ADDENDUM NO. 5

TO: PLANS AND SPECIFICATIONS FOR STATE OF MISSOURI

Renovate Mechanical / Electrical / Life-Safety / State Office Building
Jefferson State Office Building
205 Jefferson Street
Jefferson City, MO 65101
PROJECT NO. O1911-01

1 DEMOLITION PLAN - SECOND FLOOR
A-102 1/8" = 1'-0"

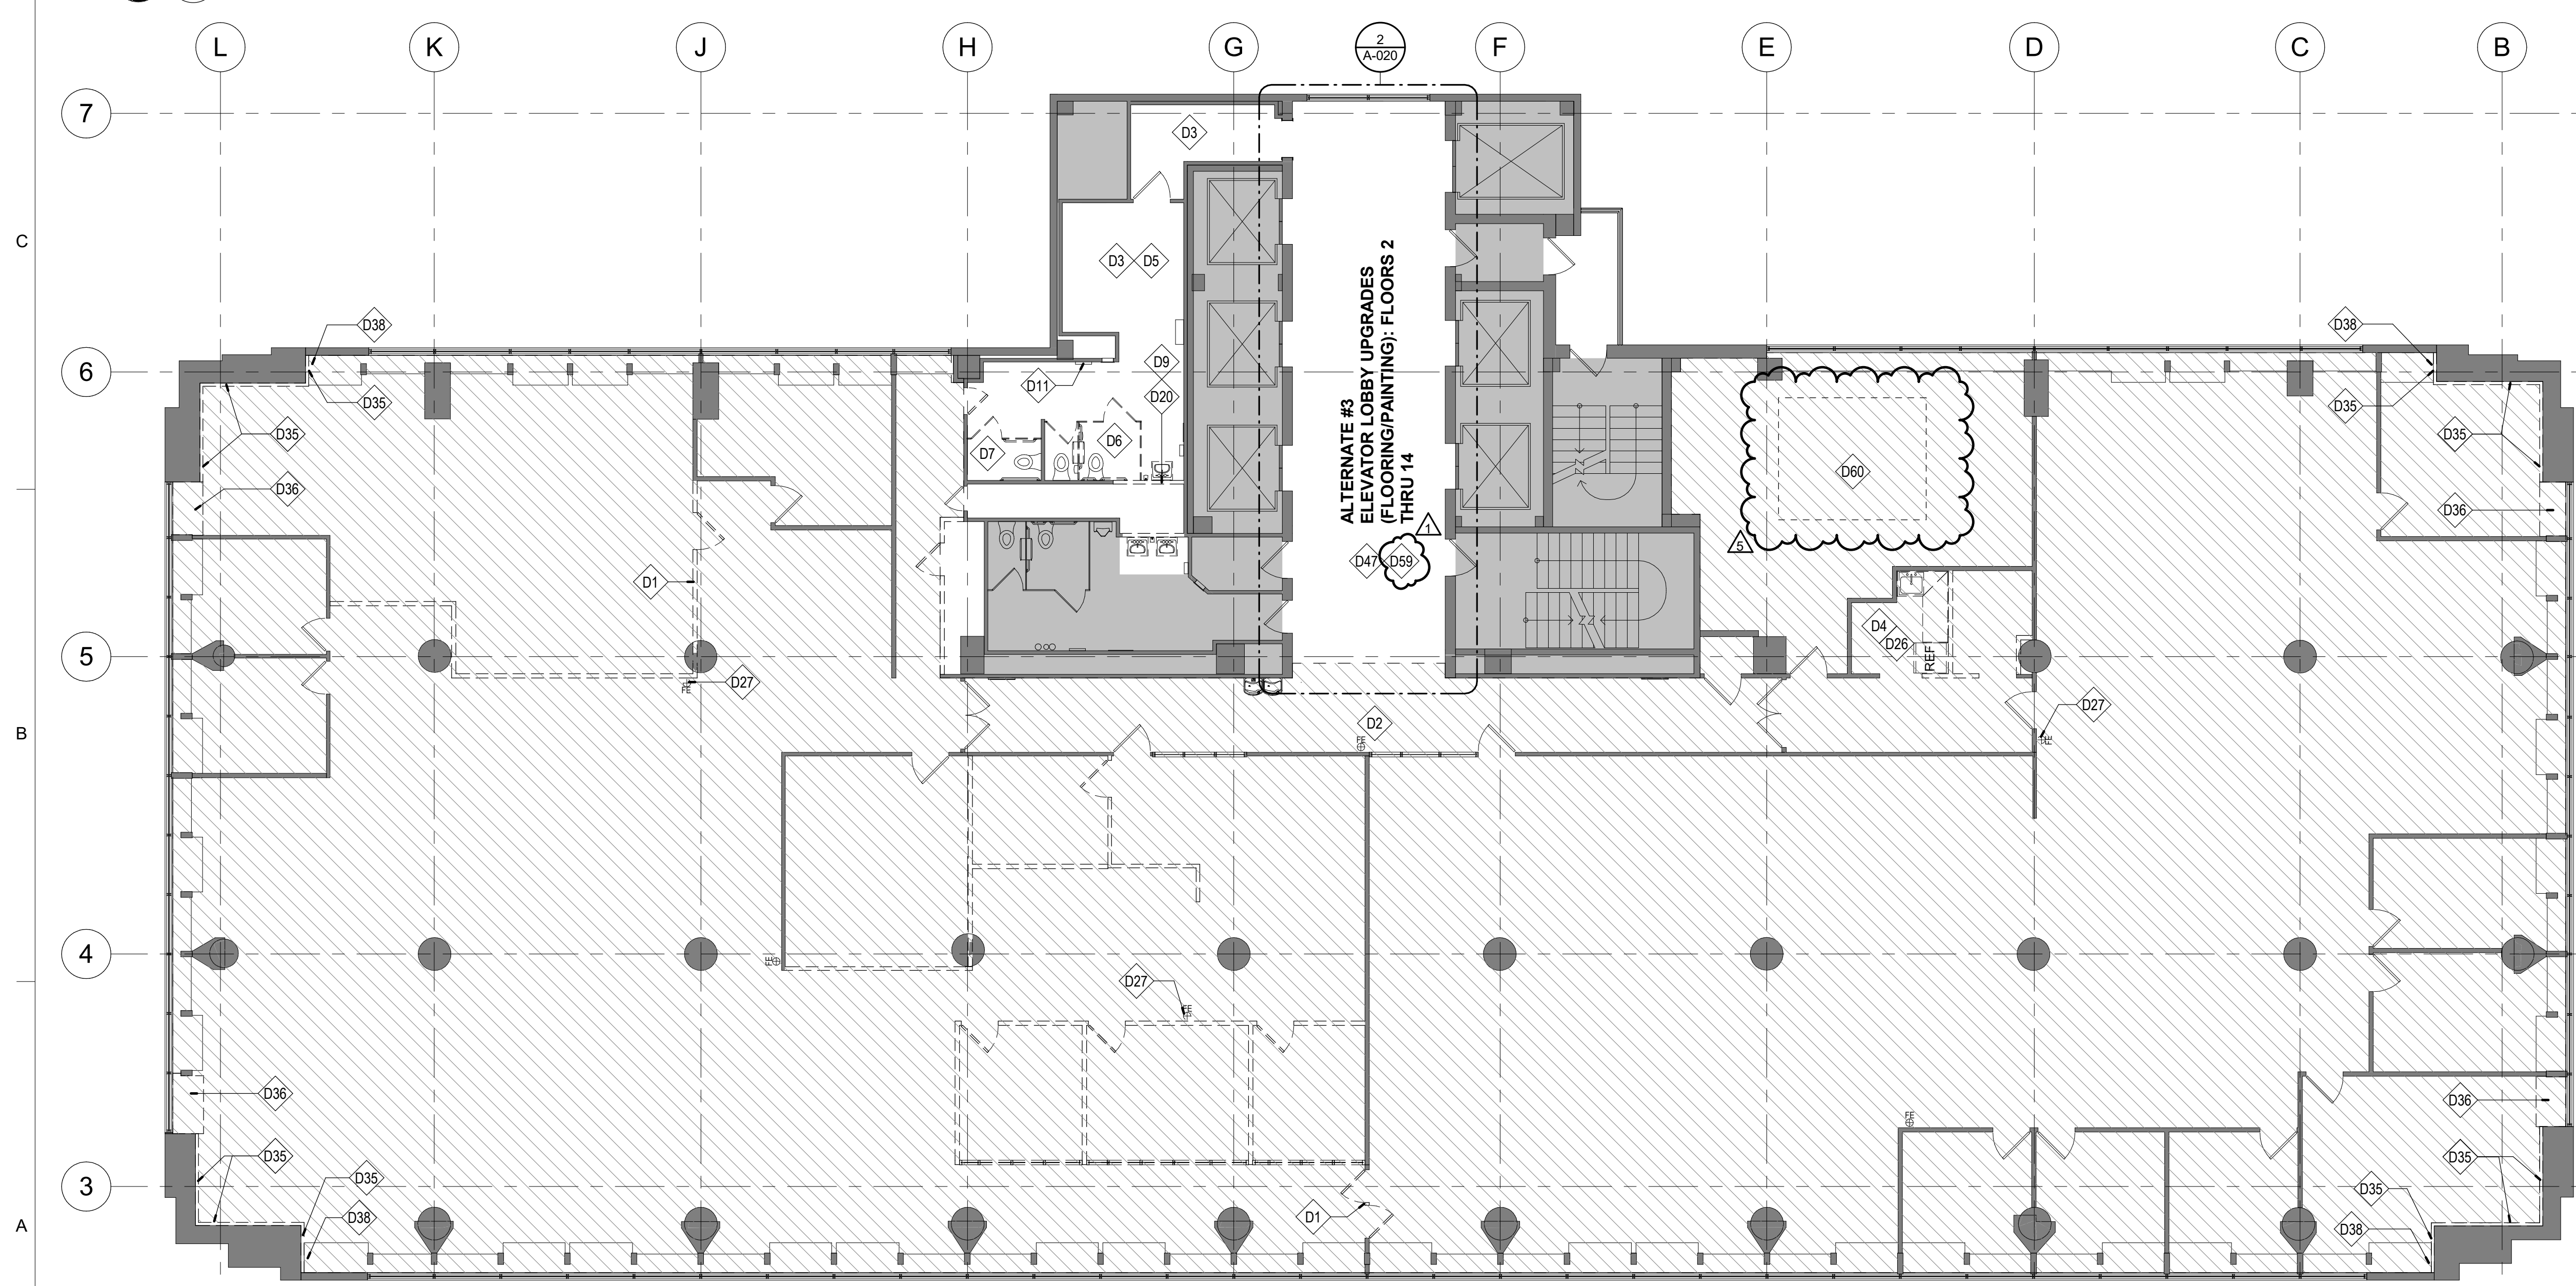
4. Drawing A-102:
 - a. ADD – Second Floor (North Wall) - Demolition Keyed Note D64: REMOVE EXISTING LAMINATE COUNTERS AT FAN COIL UNITS (FCU) TO CUT AND INSTALL ADDITIONAL DIFFUSER PER MECHANICAL SCOPE

5. Drawing A-102 through A-107:
 - a. ADD – Mechanical Rooms – existing housekeeping pad removal (Demolition Keyed Note D60).
 6. Drawing A-108:
 - a. ADD – Penthouse Demolition Plan (2/A-108) and show removal of existing housekeeping pad (Demolition Keyed Note D60).

A-121
42 OF 240

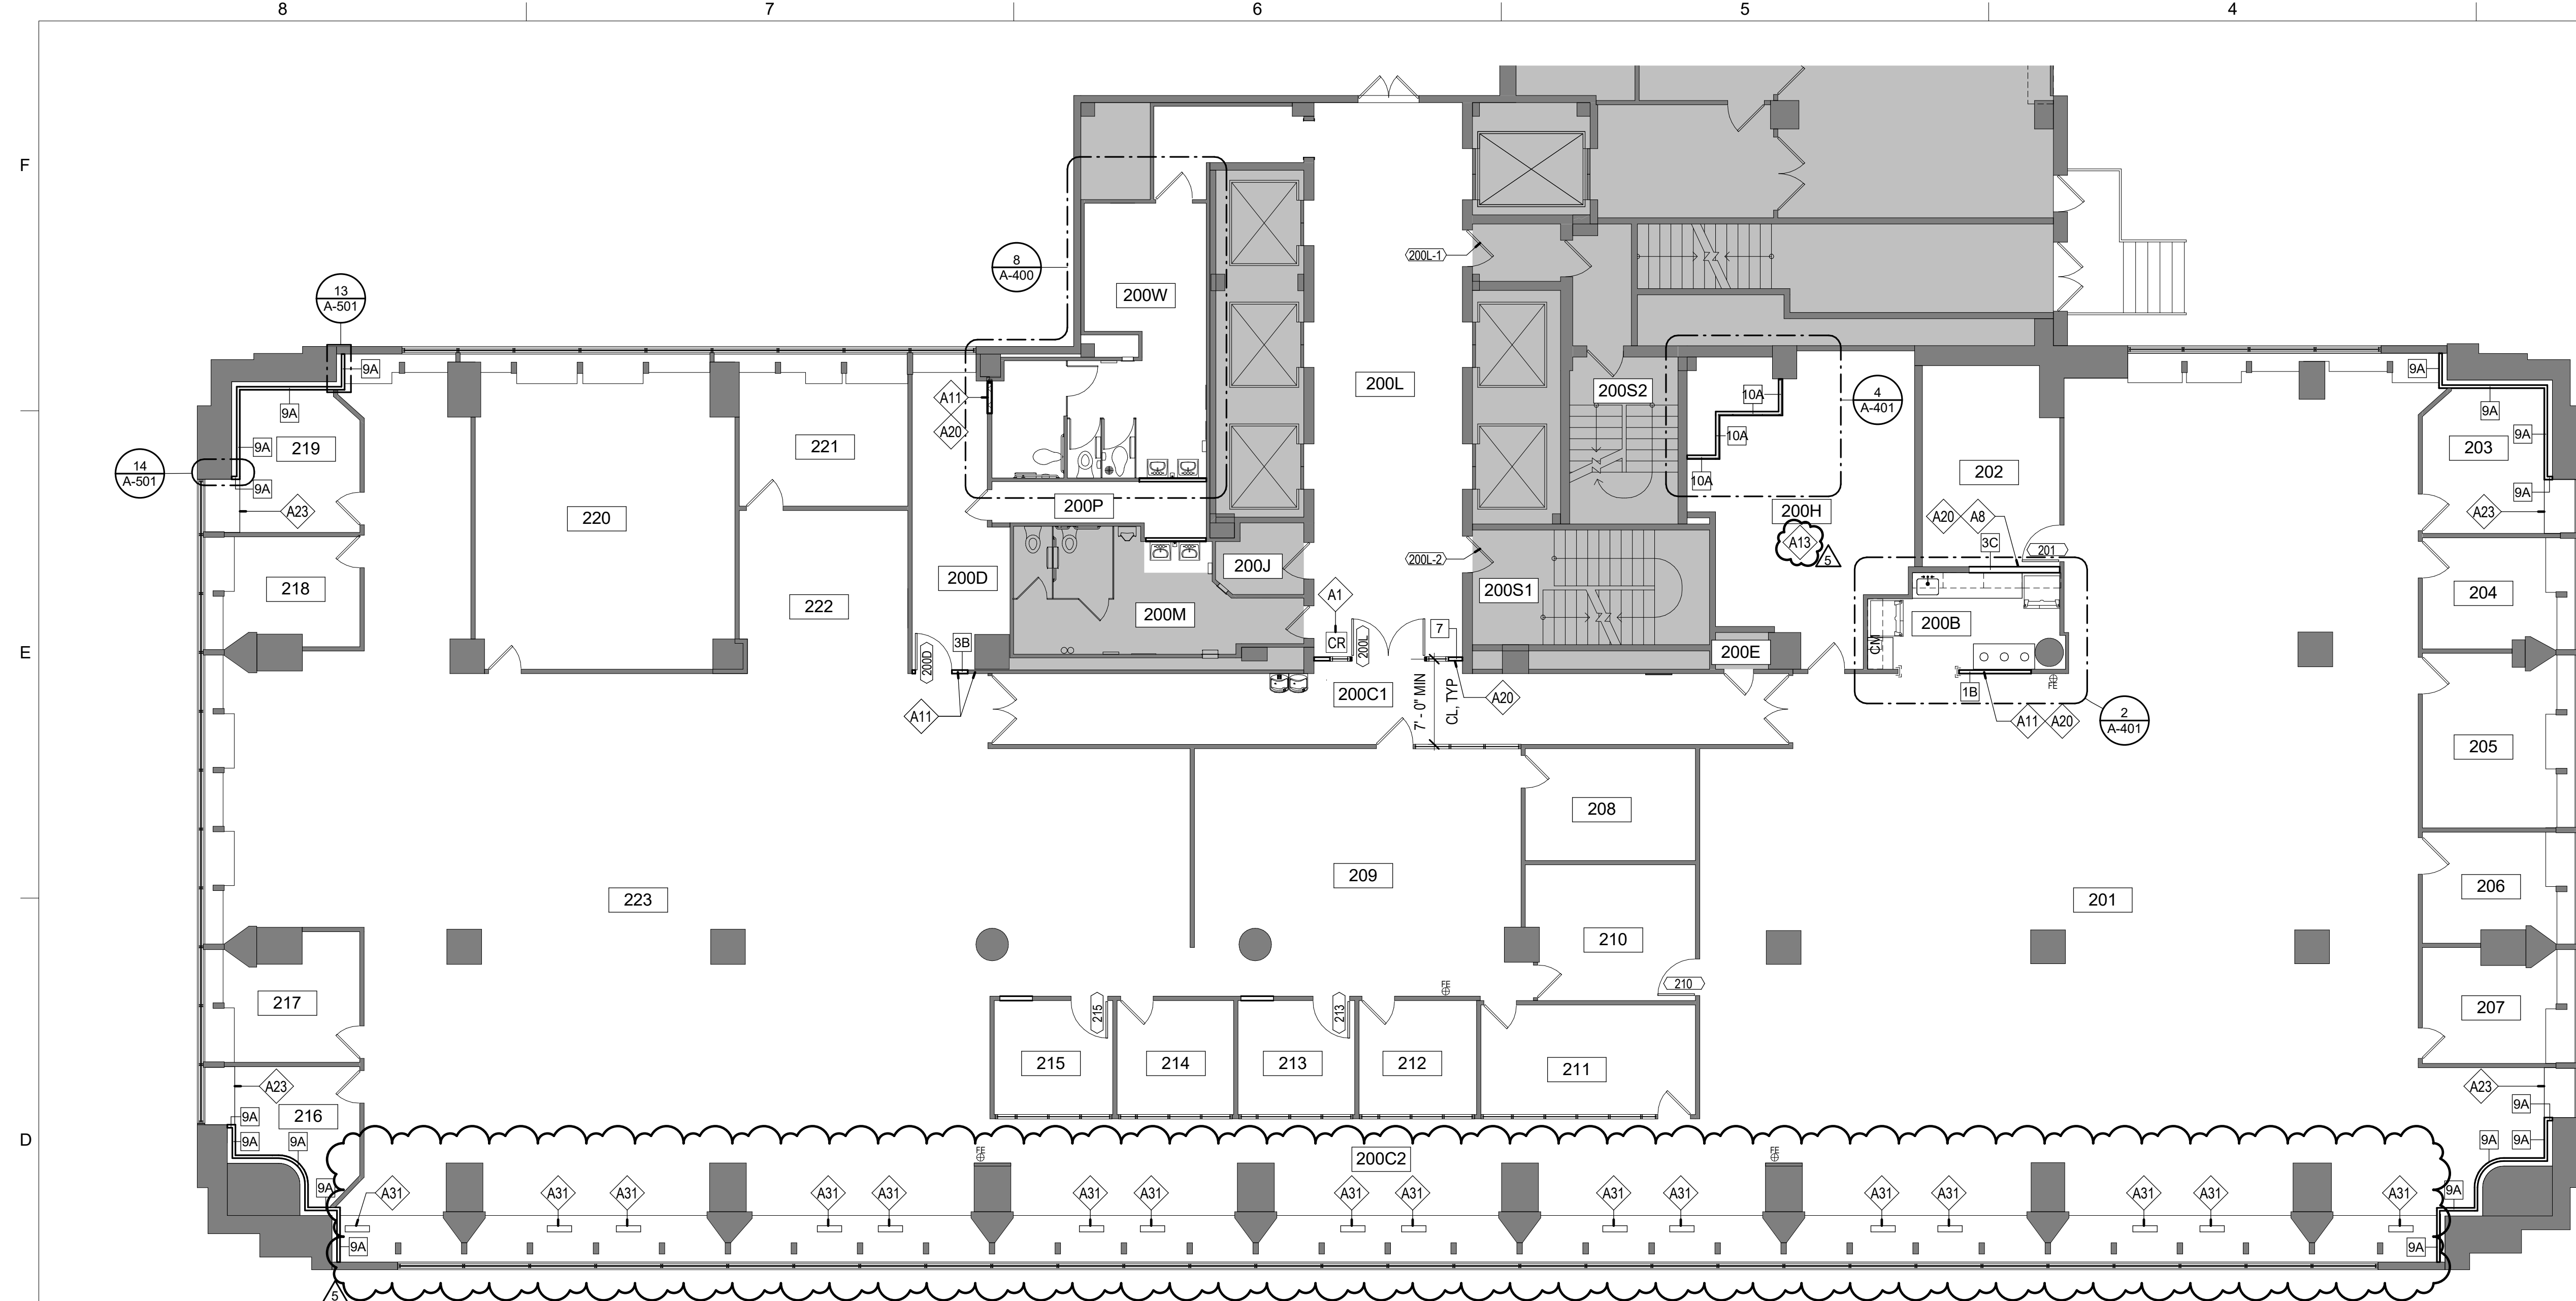
8. Drawing A-121:
 - a. ADD – Mechanical Room 100H to scope and show new equipment housekeeping pad.
 - b. ADD – Mechanical Room 100H - Architectural Keyed Notes A13 & A29

1 FLOOR PLAN - SECOND FLOOR
1/8" = 1'-0"

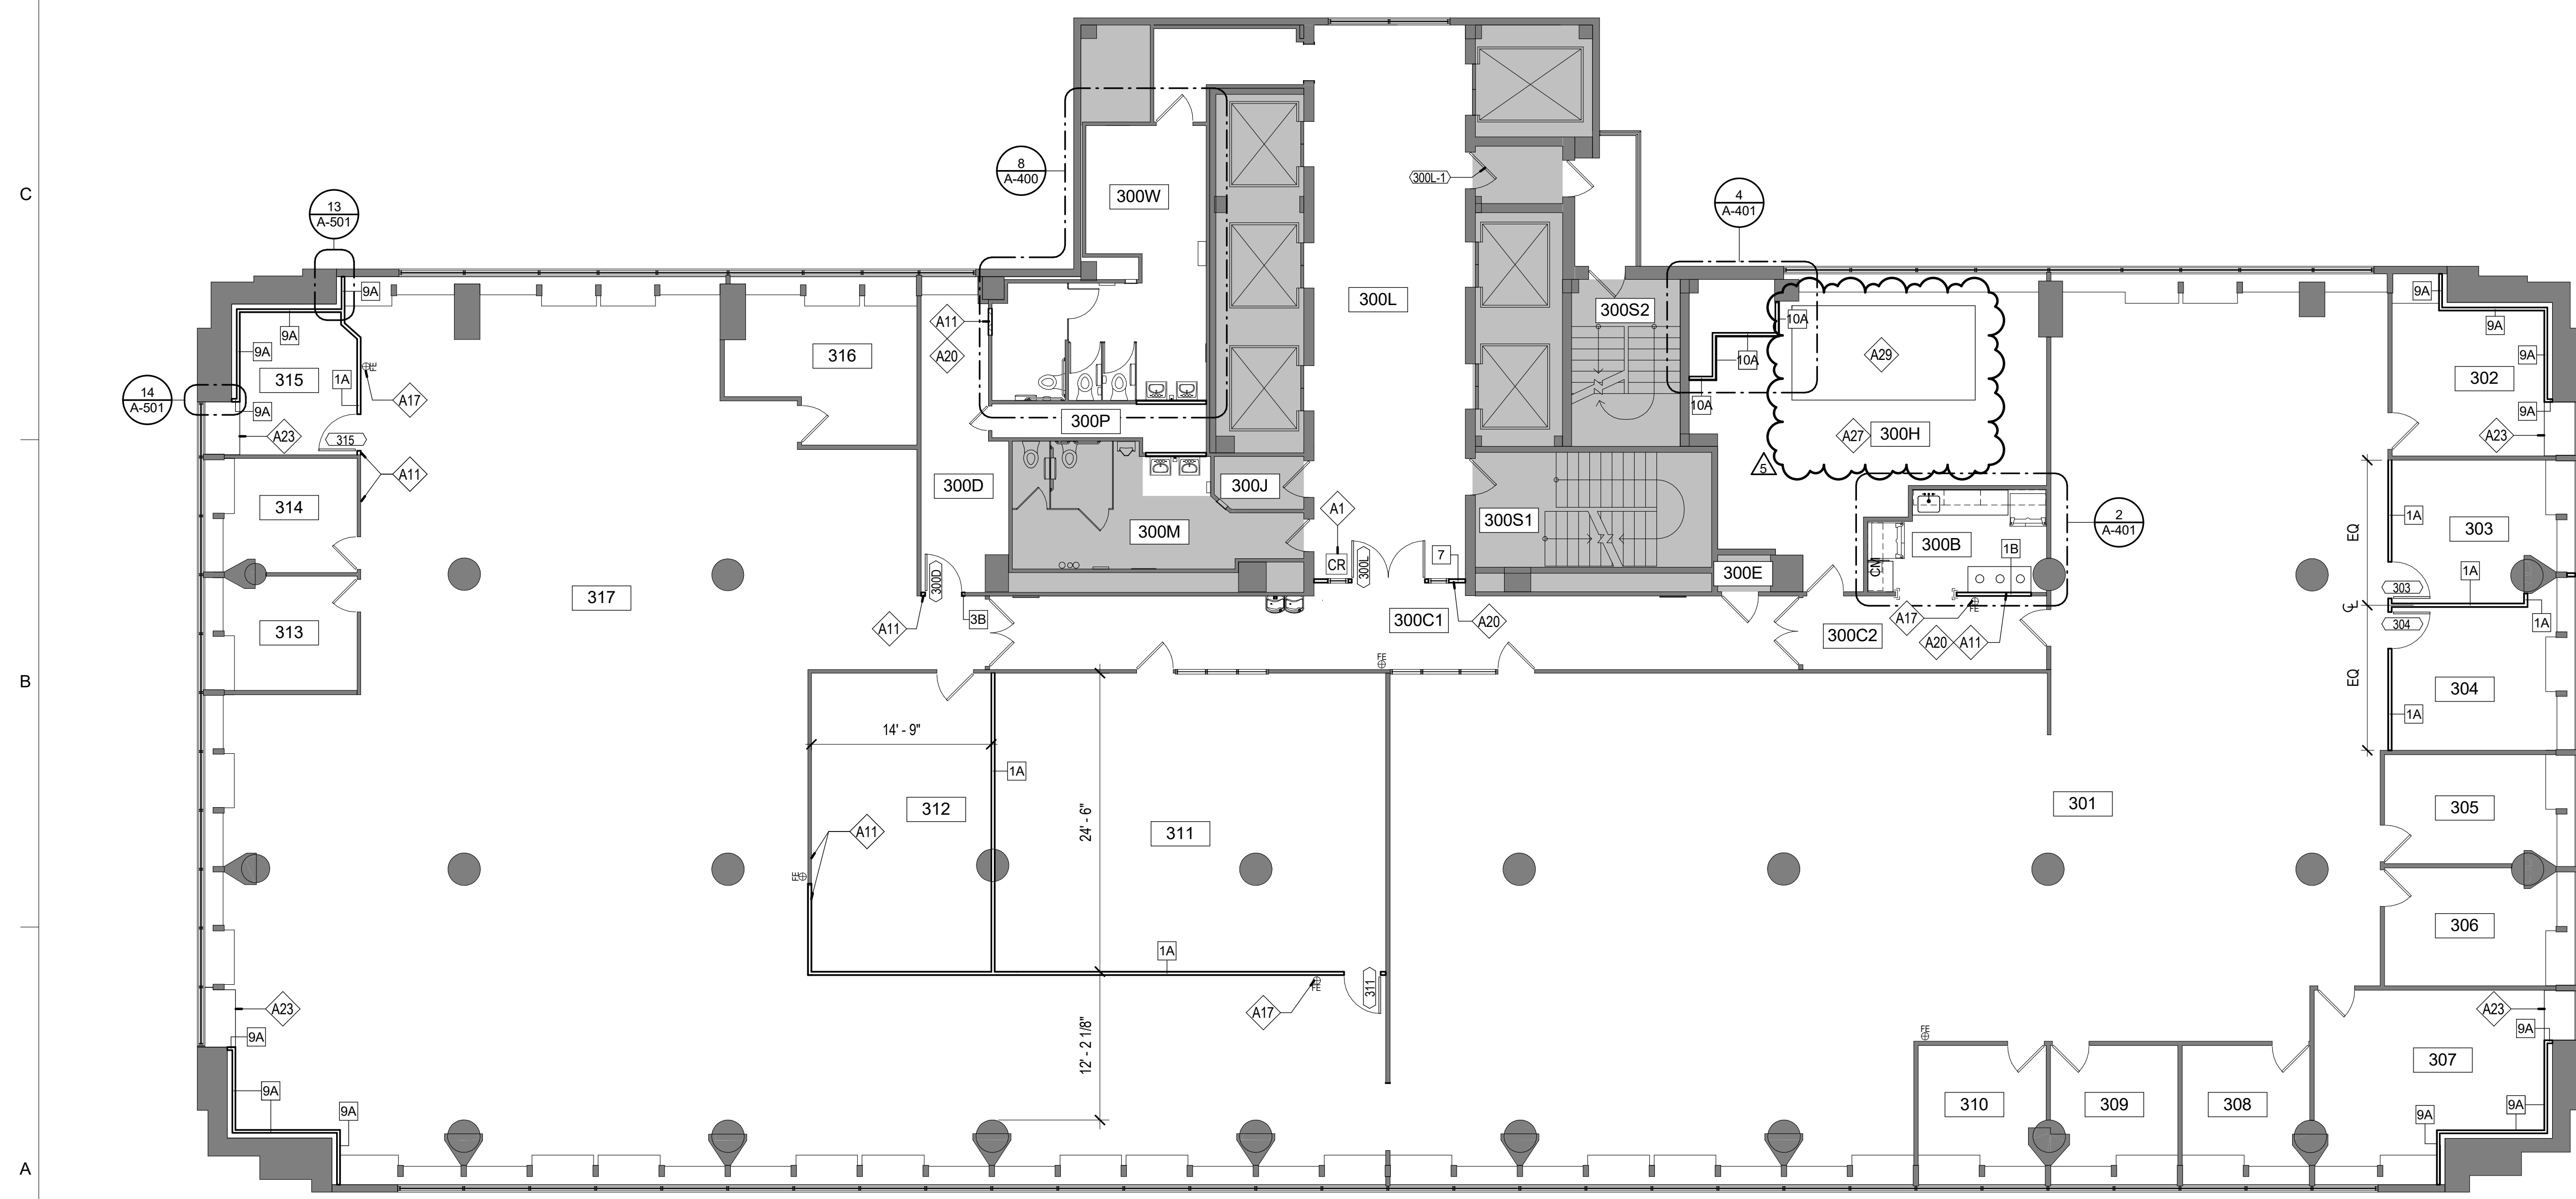
- a. ADD – Second Floor (North Wall) – Architectural Keyed Note A31: CUT IN NEW SCHEDULED (24"X6") DIFFUSERS IN EXISTING PLASTIC LAMINAE COUNTER, AS INDICATED ON MECHANICAL DRAWINGS

10. Drawing A-122 through A-127:
- a. ADD – Even Floors (2, 4, 6, 8, 10, & 12) Mechanical Rooms: Architectural Keyed Note A13, to address areas where housekeeping pads have been removed and the existing slab will be painted.
